SAUSALITO-MARIN CITY SANITARY DISTRICT

ADDENDUM NO. 1

**Treatment and Wet Weather Flow Upgrade
(Project No. 0055-006)**

January 5, 2017

15 WALL COLOR AND FINISH
(NOT TO SCALE)

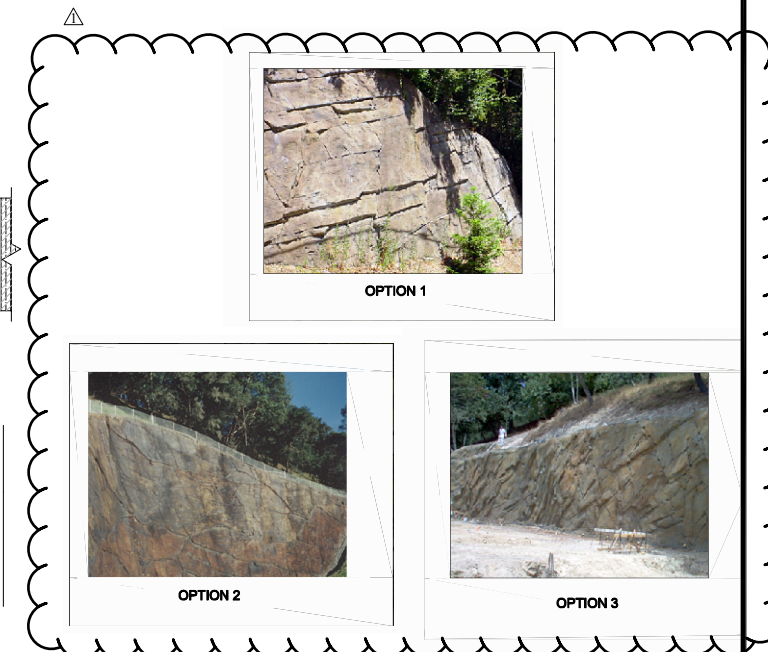
- 1.03 Sheet 47, Dwg No. C110-4 GEOTECHNICAL SOIL NAIL WALL DETAILS**
Change: In Detail 15, replace wall finish Options 1, 2, and 3 as shown on Attachment No. 7.

DWG NO	S030-1
SHEET NO	96 OF 226
PROJ NO	055-006
DATE	NOVEMBER 2016

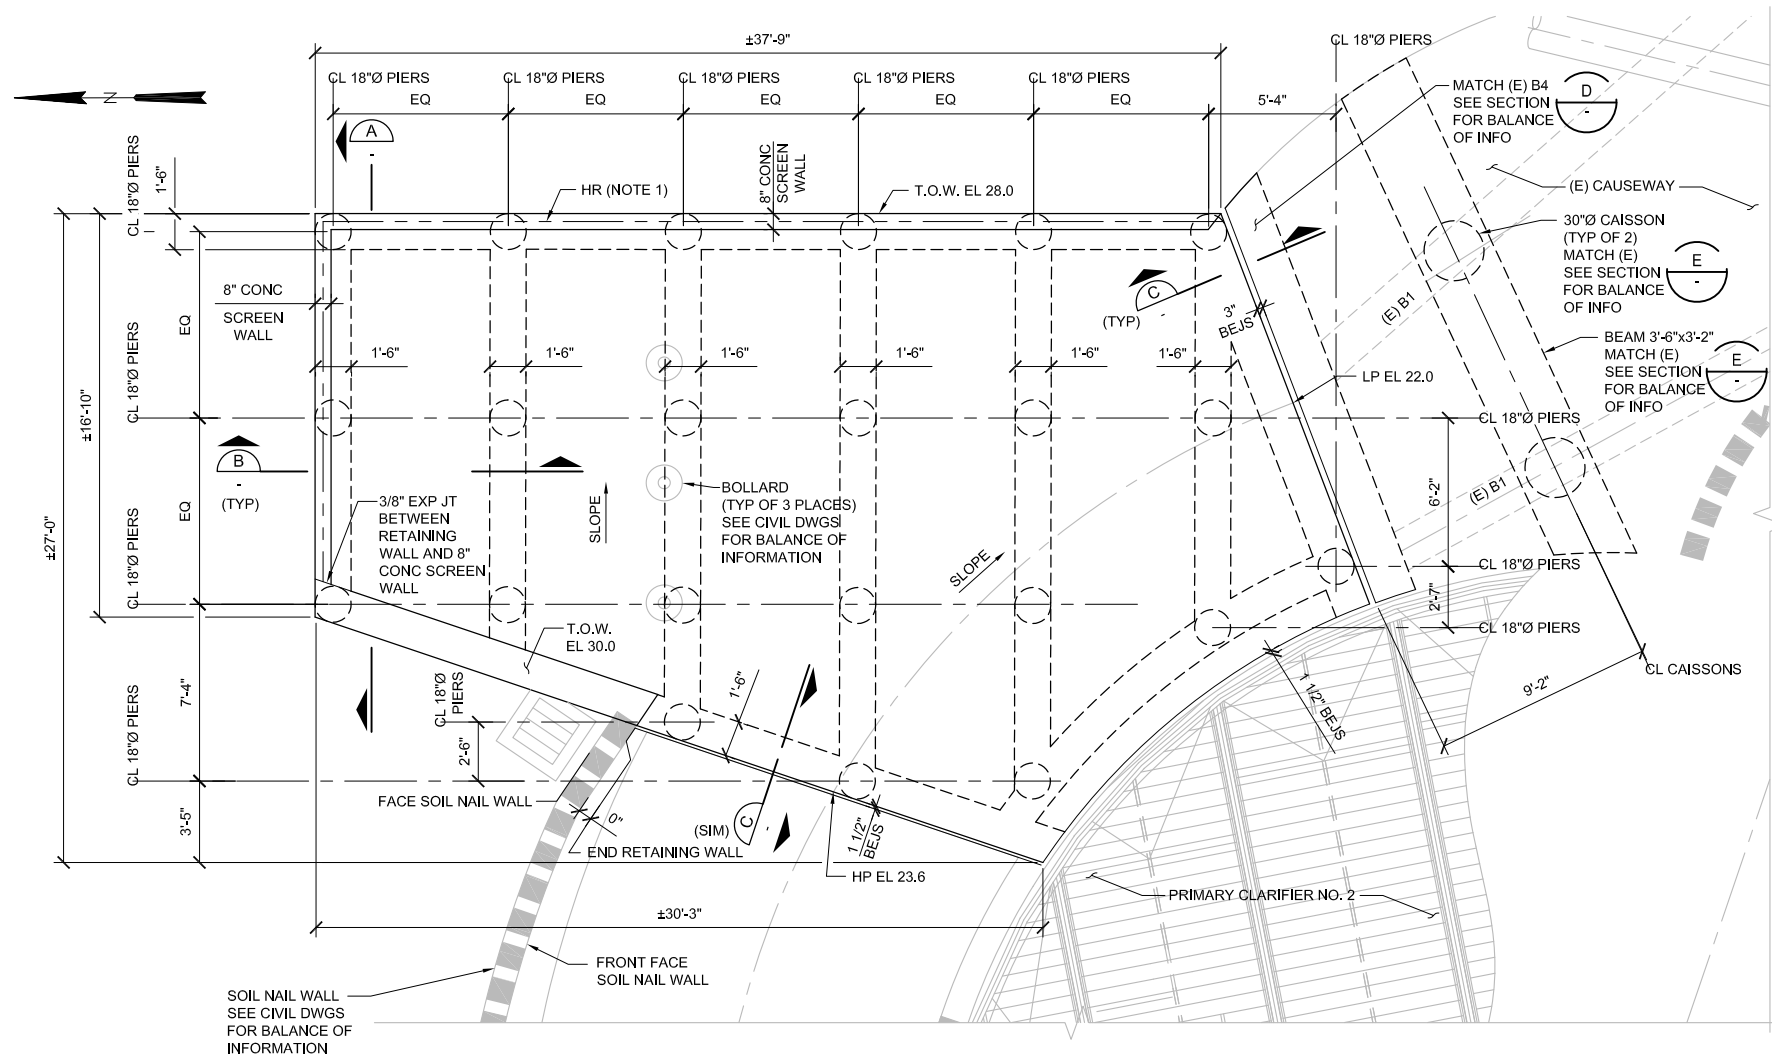
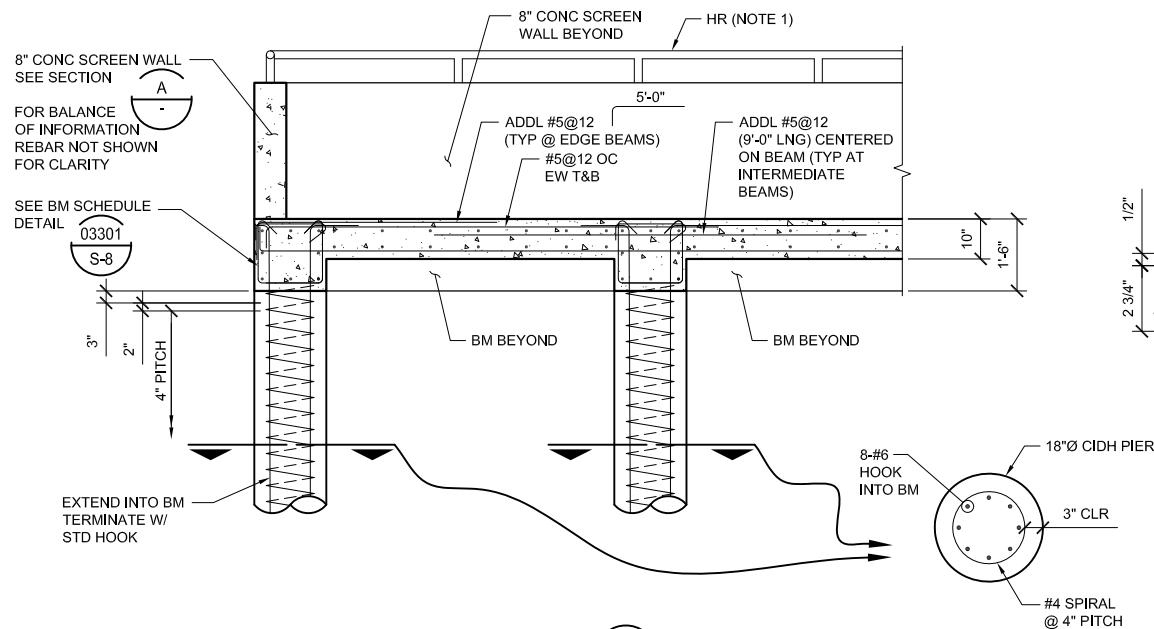
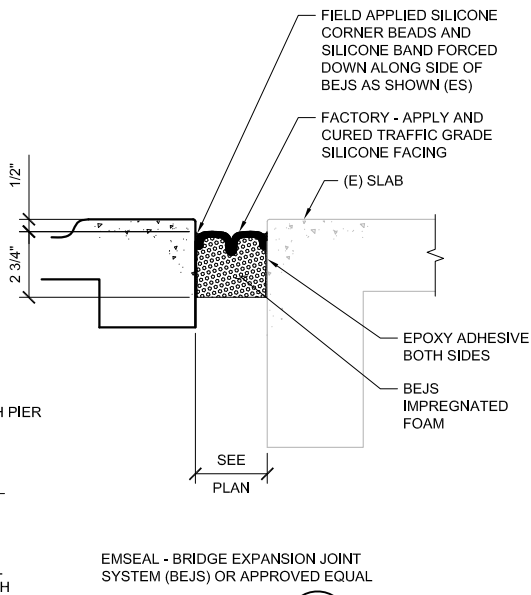
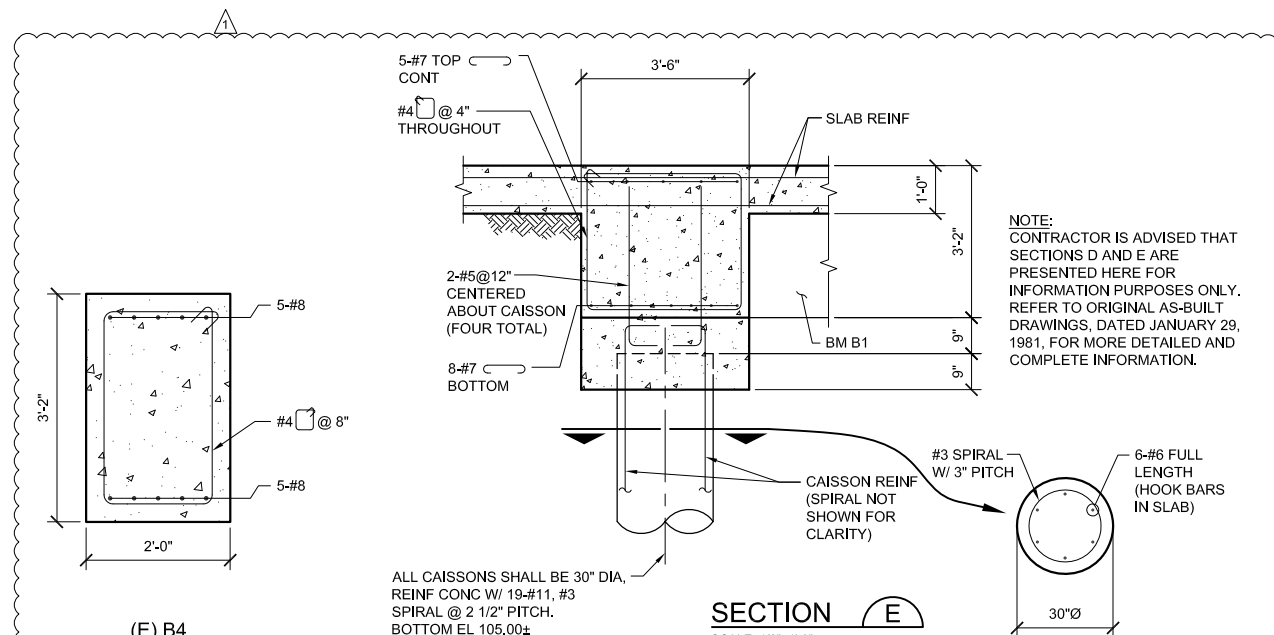
- 1.04 Sheet 96, Dwg. No. S030-1, VIEWING AREA**
Change: Delete Sheet 96, Dwg. No. S030-1 in its entirety and replace with version as provided in Attachment No. 7.

DWG NO	S200-1
SHEET NO	108 OF 226
PROJ NO	055-006
DATE	NOVEMBER 2016

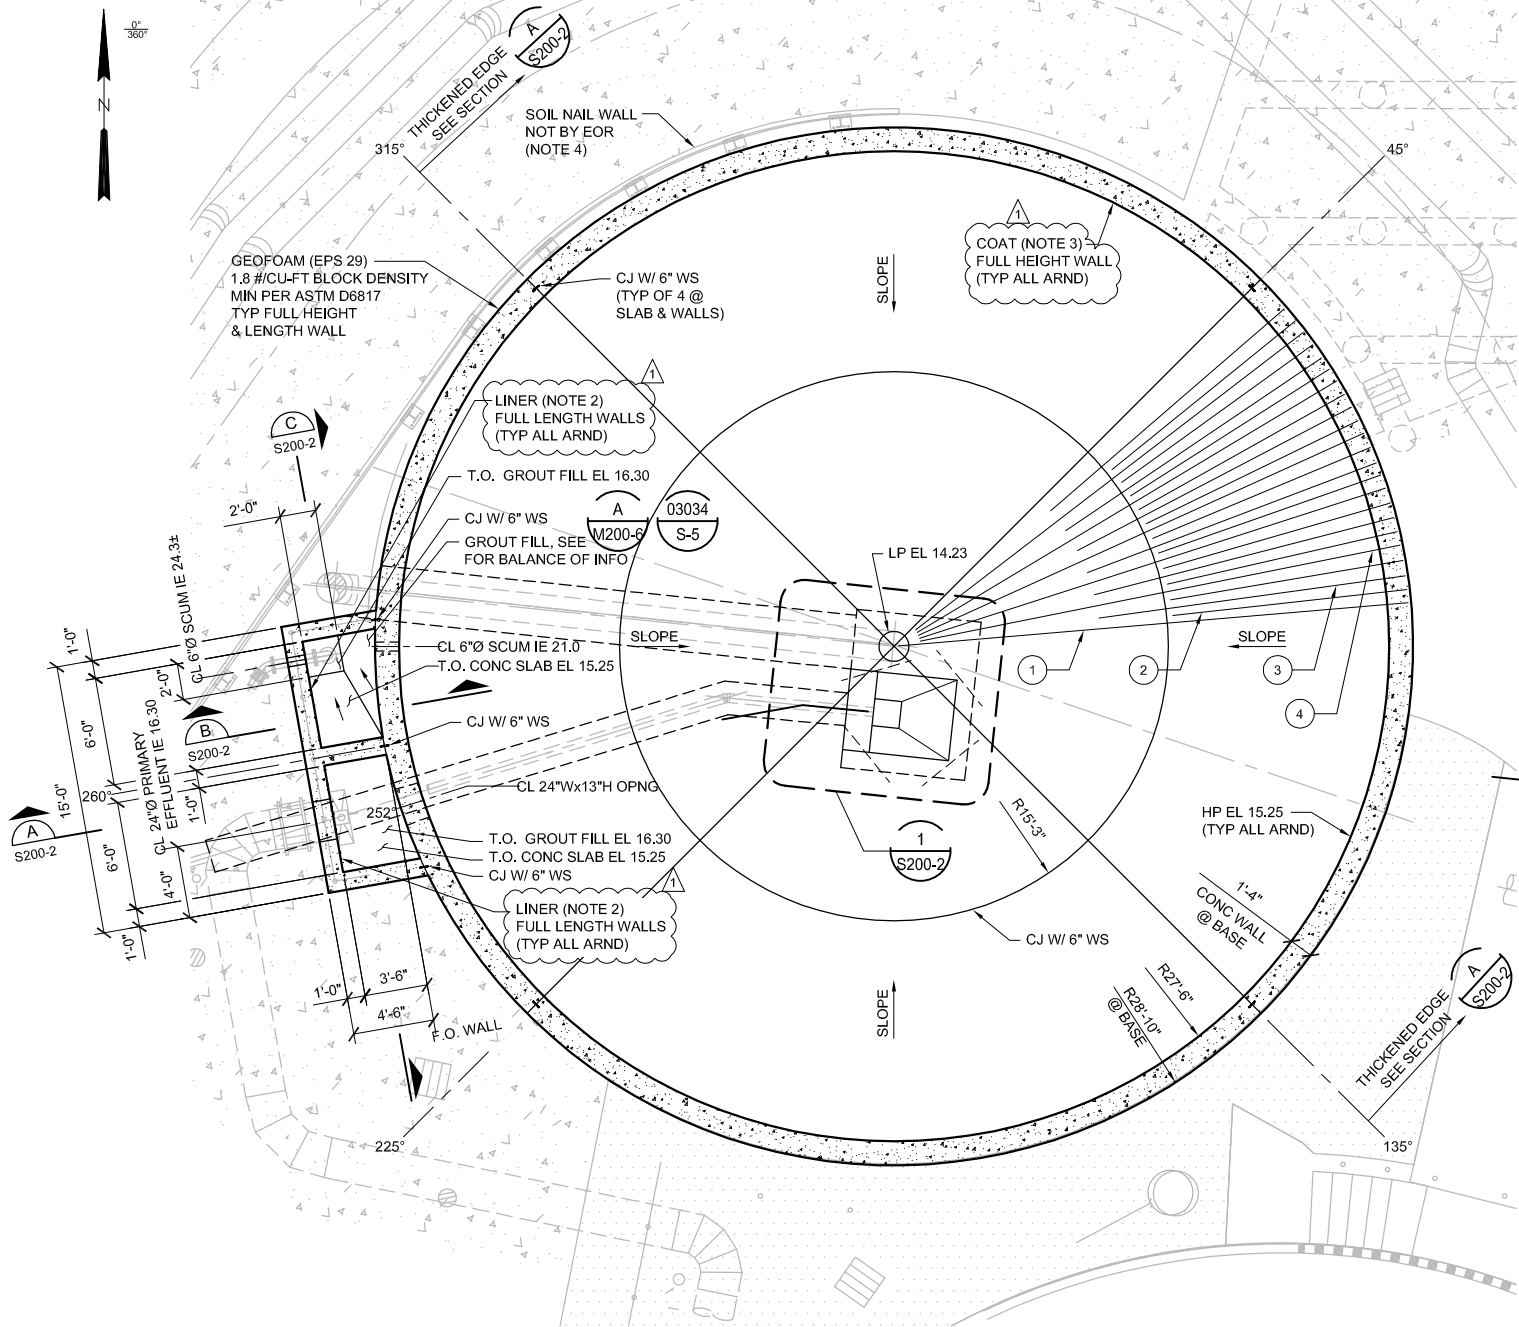
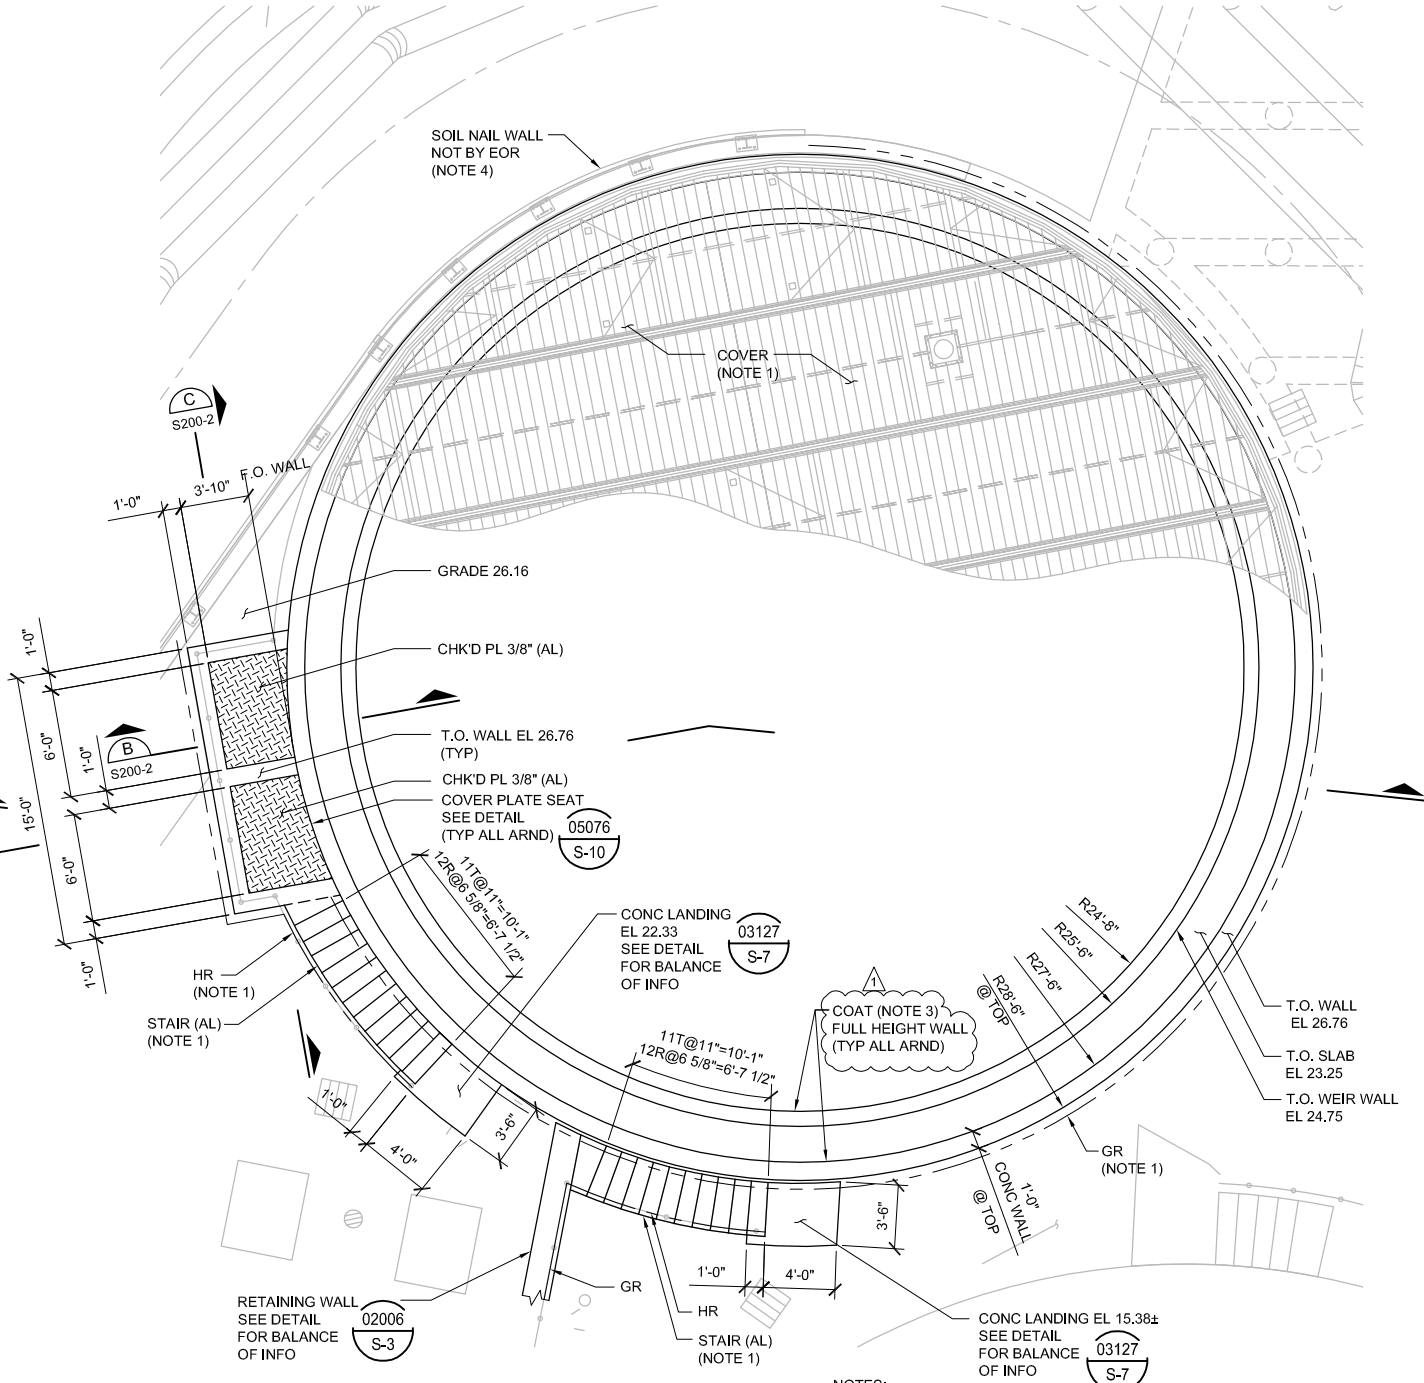
- 1.12 Sheet 108, Dwg. No. S200-1, PRIMARY CLARIFIER NO. 2 FOUNDATION AND TOP PLANS**
Change: Delete Sheet 108, Dwg. No. S200-1 in its entirety and replace with version as provided in Attachment No. 7.
